**Subject: NEXTERA BLYTHE SOLAR ENERGY CENTER LLC'S RESPONSE TO
CEC STAFF DATA REQUEST SET 1 (1-19)
BLYTHE SOLAR POWER PROJECT AMENDMENT
DOCKET NO. (09-AFC-6C)**

BLYTHE SOLAR POWER PROJECT (09-AFC-6C)

RESPONSES TO DATA REQUESTS – SET 1

ATTACHMENT DR 19
EMERGENCY PLAN OUTLINE AND EXIT FIGURE

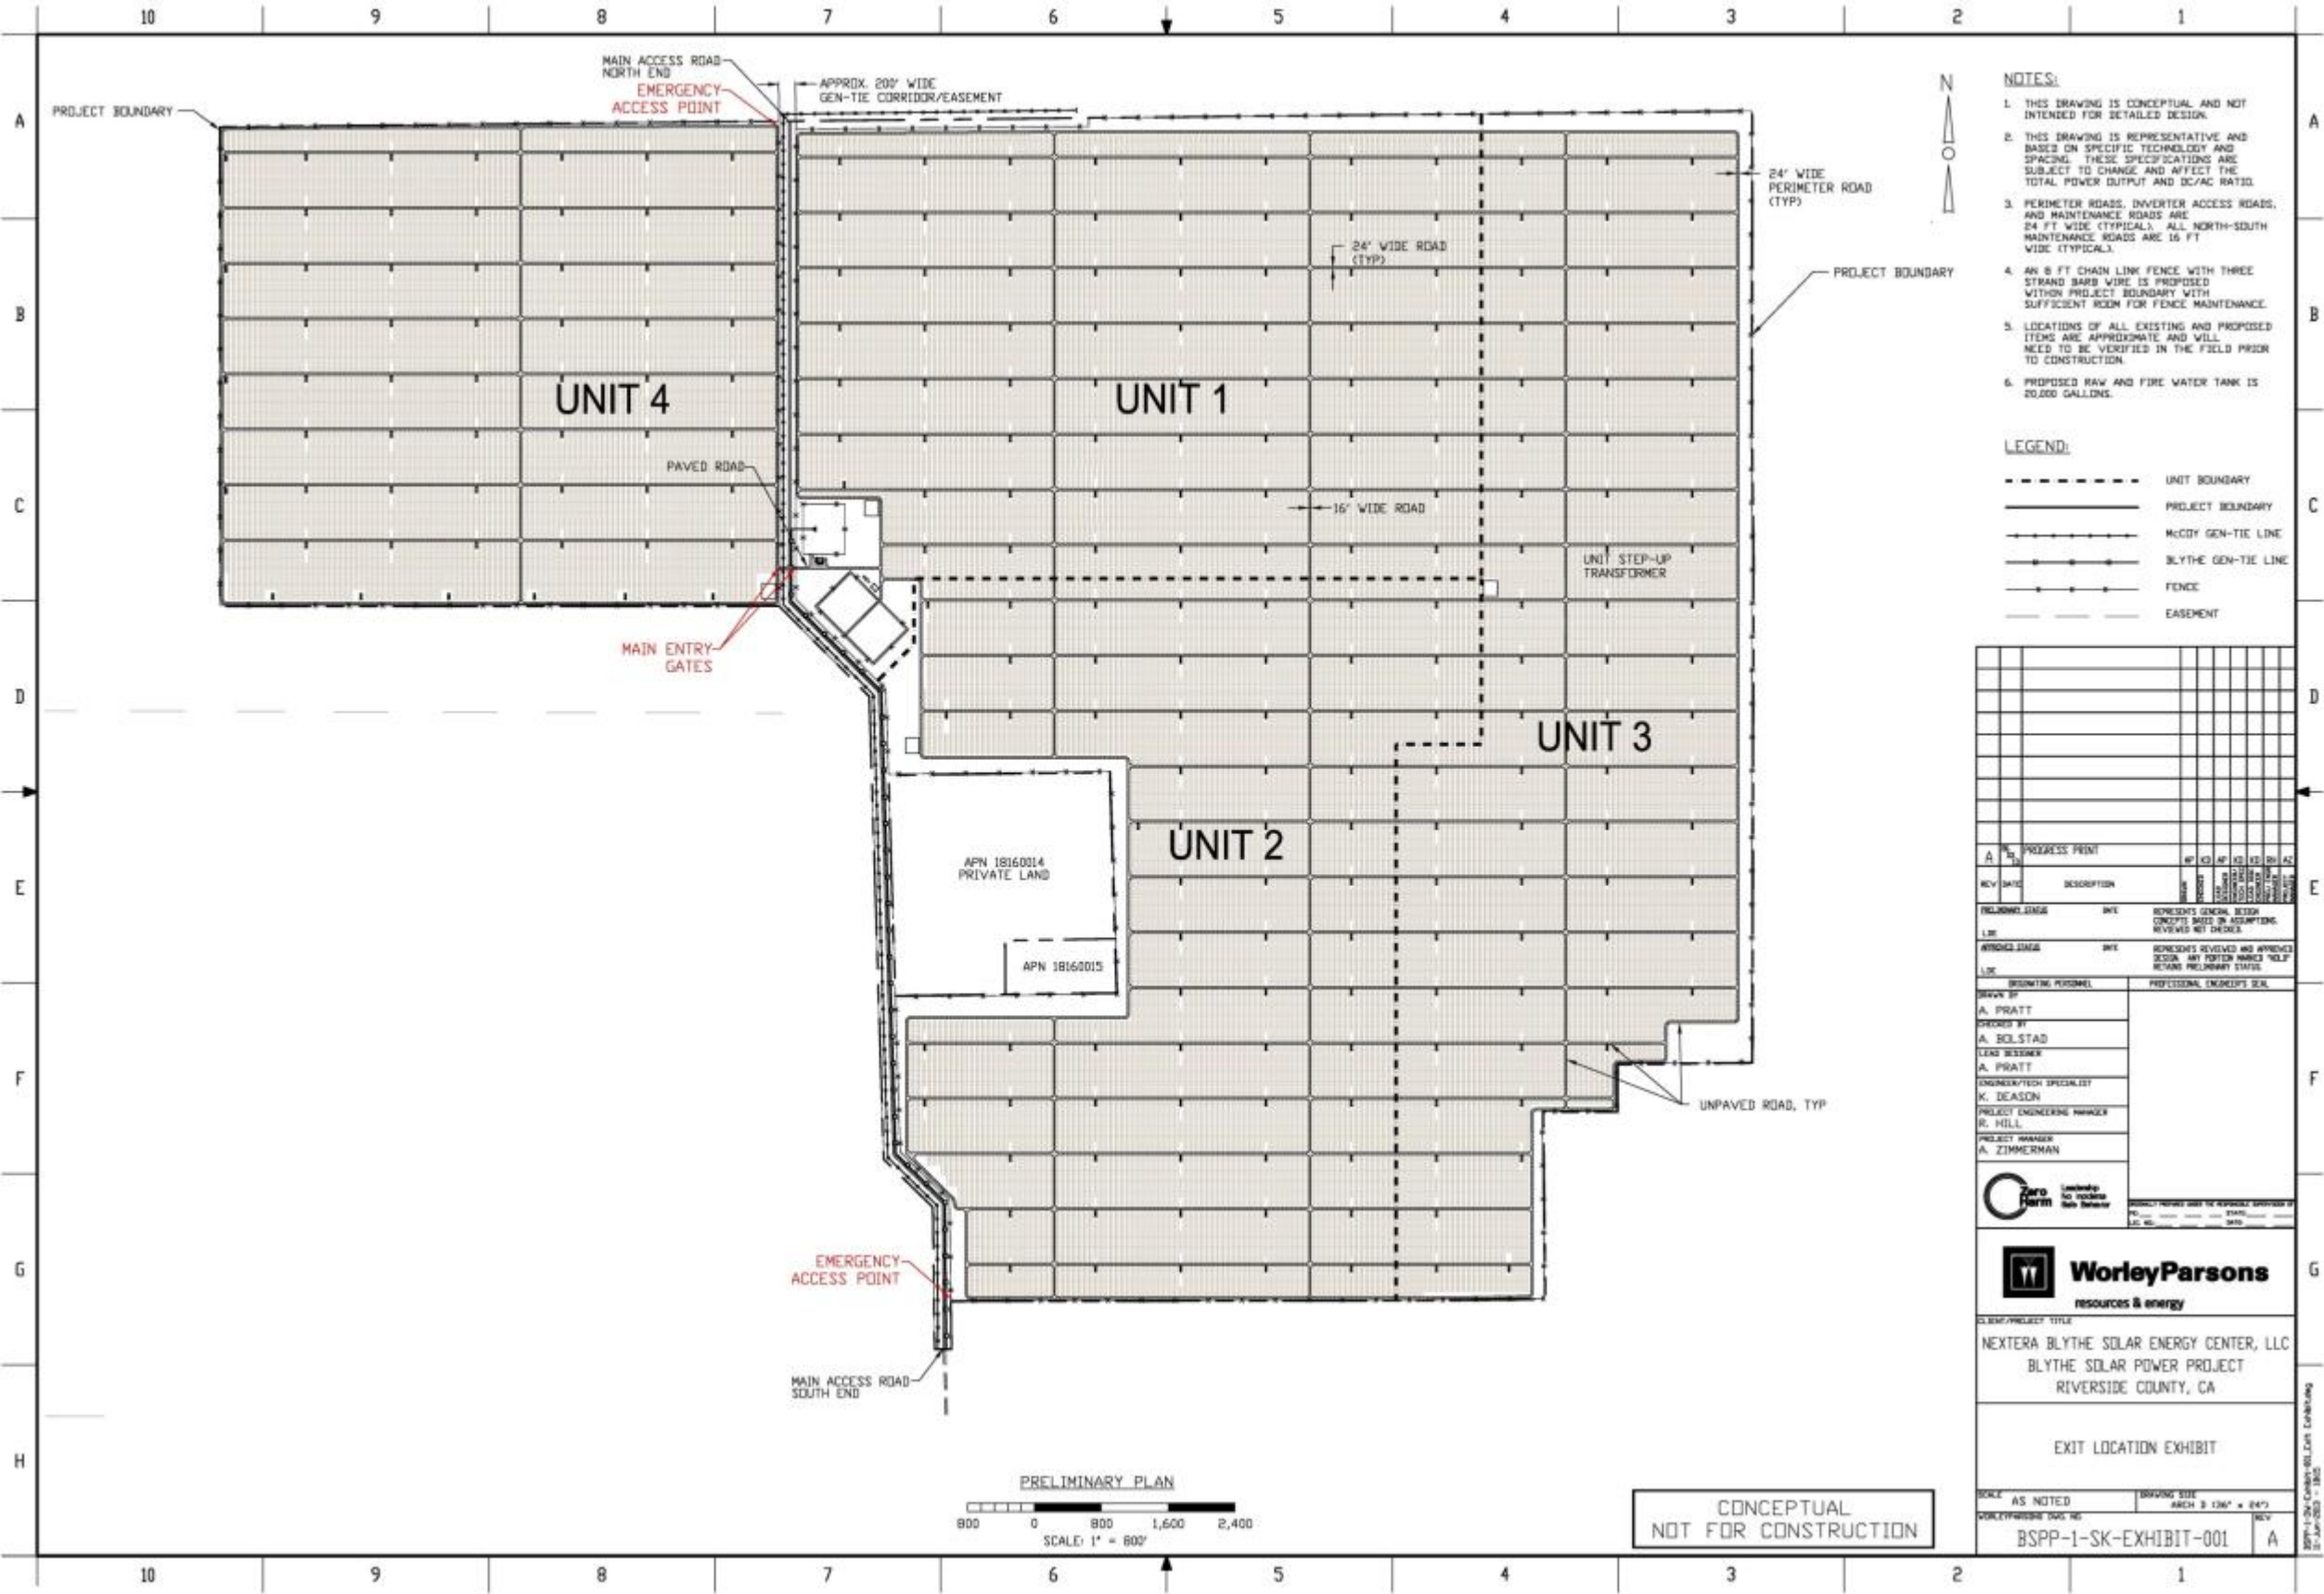
19. Please identify safety measures, including engineering controls and administrative controls (Best Management Practices) that will be implemented to protect workers and emergency responders when a fire or other event that necessitates a response occurs that involves solar panels.

As shown on the layout in Attachment DR 19-1, emergency egress will be provided throughout the site in a grid network of roads. The main switchyard, operations and maintenance (O&M) building, water tanks, and water treatment facilities are located near the main entrance. The roads throughout the PV arrays provide access to the Unit Step-Up Transformers, feeder disconnects, and every PCS. The roads are spaced at a maximum of 1,000 feet apart and include a 24 foot wide perimeter road. With the perimeter access road, there is also an inherent 30 foot minimum array setback from the property boundary.
